Our ref: DEV-2026-FLA-4618

Information Request and Public Notice of development application
Notice given under section 83(1) of the Economic Development Act 2012

Priority Development Area (PDA):	Greater Flagstone PDA
PDA Development Type:	Development Permit for MCU for an educational establishment, childcare centre, community facility and health care services
Property Location:	New Beith Road, Silverbark Ridge
Property Description:	Part of Lot 911 on SP356636

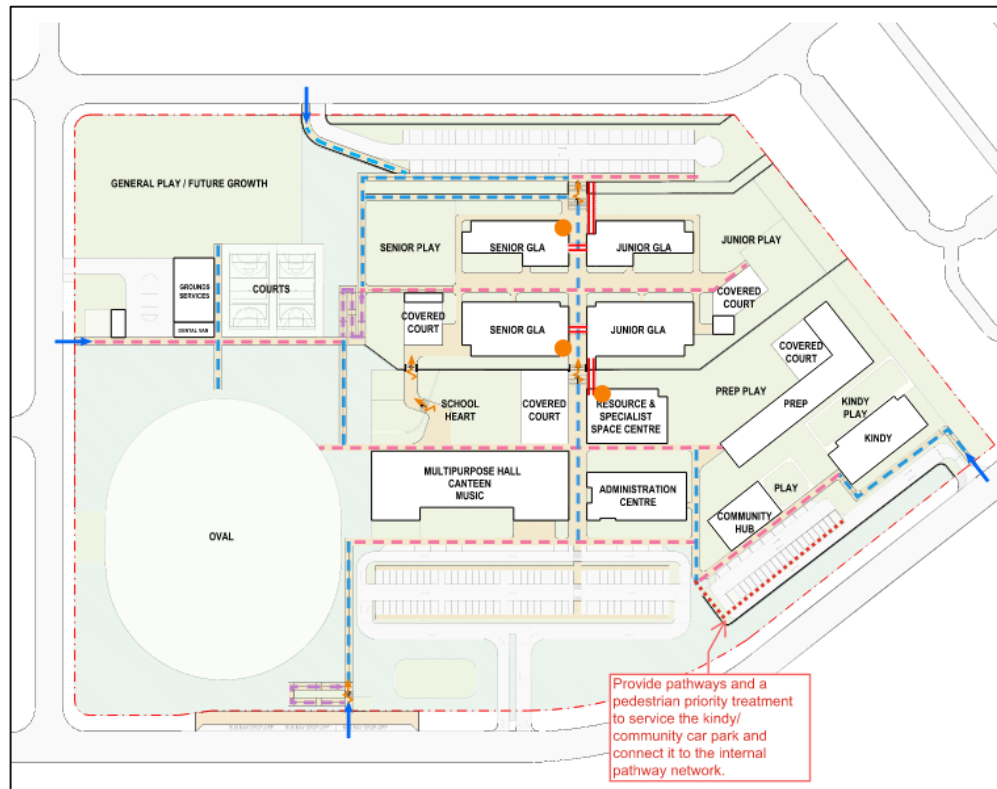
- e. Provide another pedestrian access point to the Trunk Collector (southern frontage) between the two vehicle crossovers.
 - f. Provide pathways and a pedestrian priority treatment to service the kindy and community car park in the south-west corner of the site and connect it to the internal pathway network, as shown in the marked-up plan below.
